**CITY OF RAMSEY LAND USE APPLICATION
TECHNICAL REVIEW FILE**

DATE	12/5/13	PROJECT ADDRESS	
PROJECT. TITLE	BROOKFIELD 4 TH ADDITION- FINAL PLAT OF 32 LOTS		
ESCROW #			
DEPARTMENT:	Planning		
TECHNICAL REVIEWER:	Name: Tina Goodroad Phone: 651-967-4537 Email: tina.goodroad@stantec.com

DATE	DECEMBER 5, 2013	PROJECT ADDRESS	EAST OF MARBLE STREET, SOUTH OF 170 TH TRAIL
PROJECT. TITLE	BROOKFIELD 4 TH ADDITION FINAL PLAT		
ESCROW #	113790		
DEPARTMENT:	Engineering		
TECHNICAL REVIEWER:	Name: Leonard Linton Phone: 763 433-9834 Email: llinton@ci.ramsey.mn.us

We offer the following comments regarding your request for the Final Plat of Brookfield 4th Addition. The submittal consists of 12 sheets prepared by Anderson Passe & Associates dated November 27, 2013.

Sheet SW1

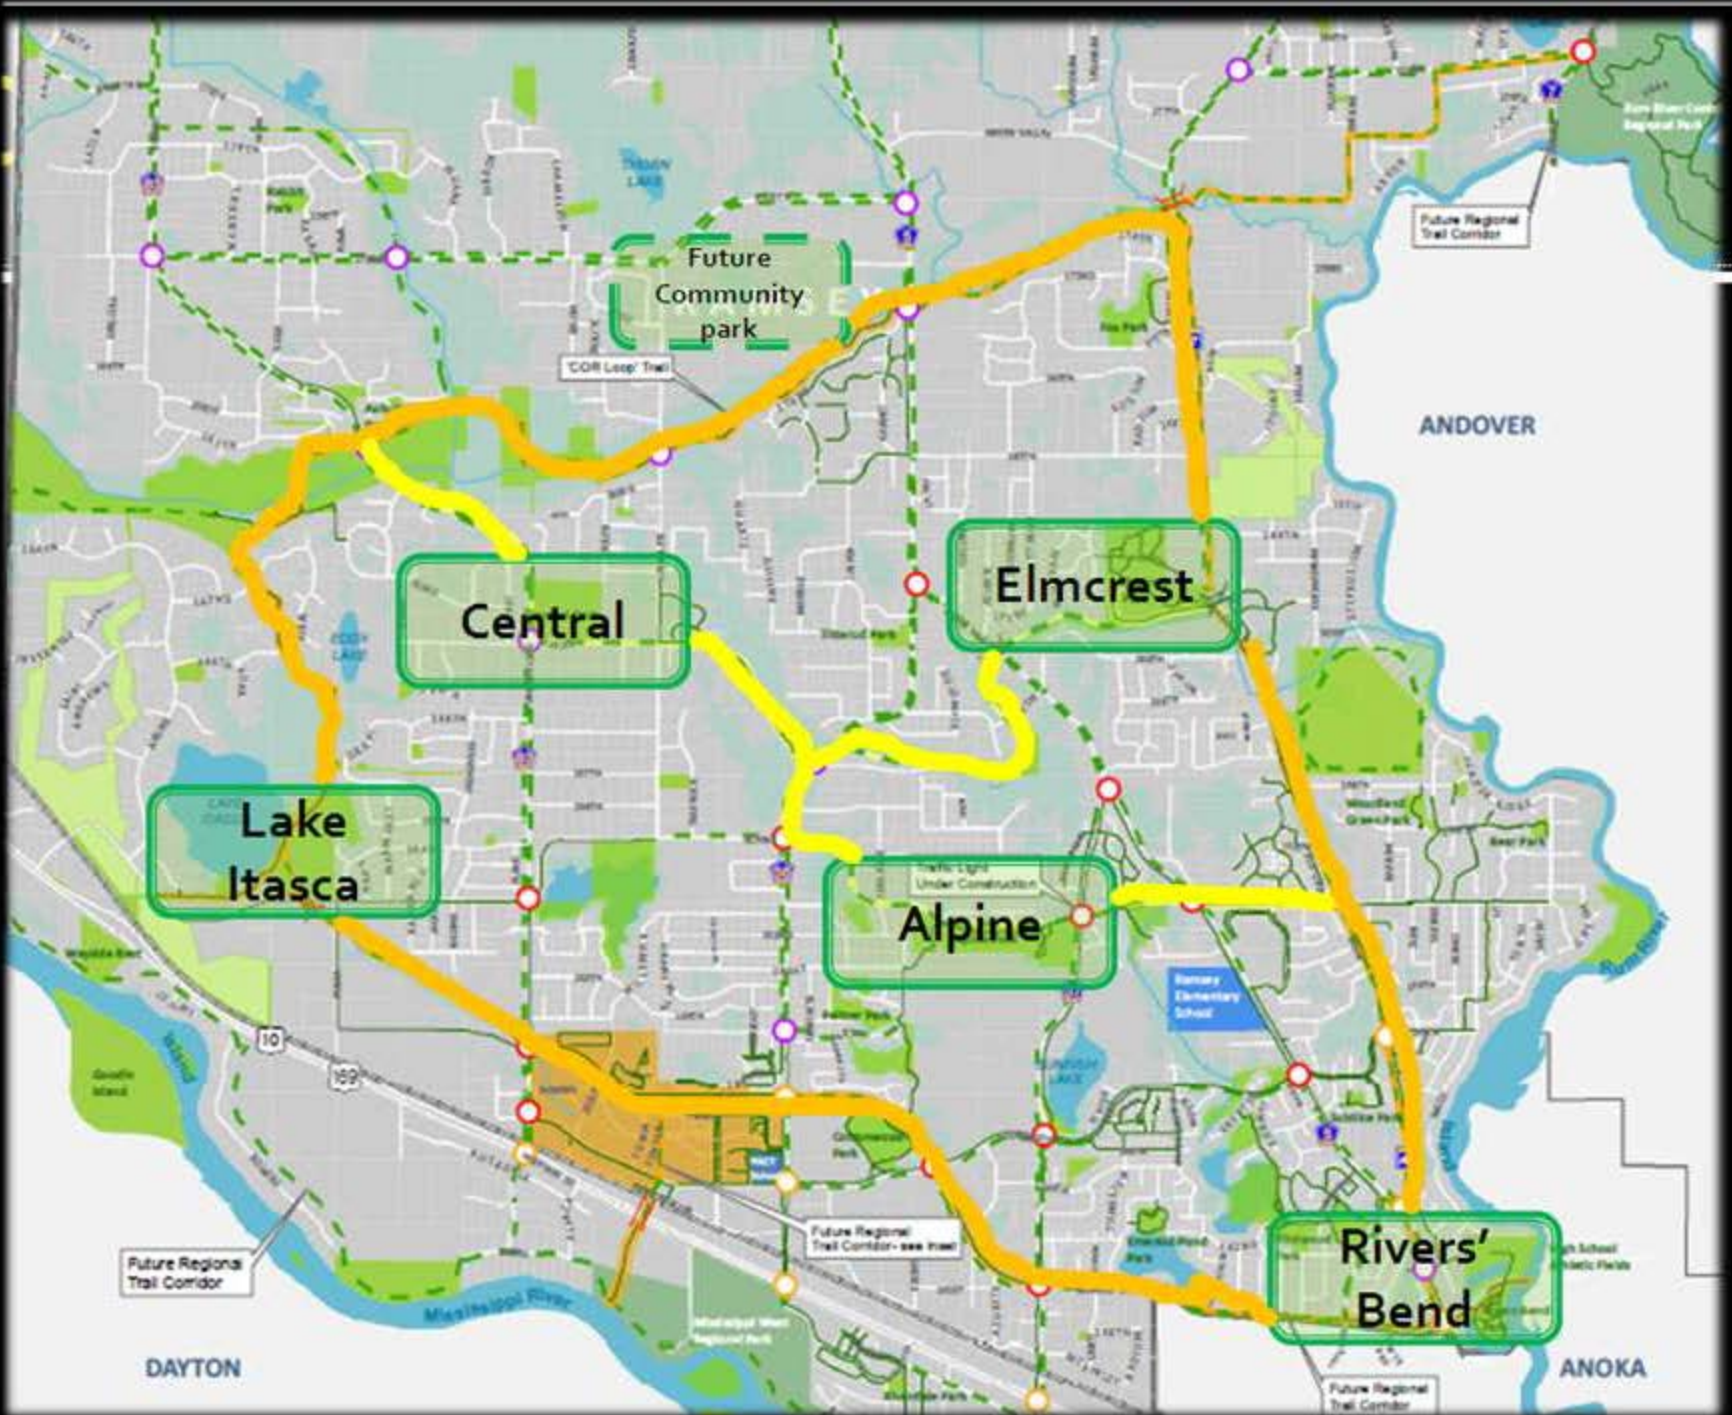
- Fill in the contact information.
- Add a site plan to the sheet set as described in paragraph 2 including surface waters within ½ mile of site.
- Revise to reflect only 31 lots are being graded at this time.
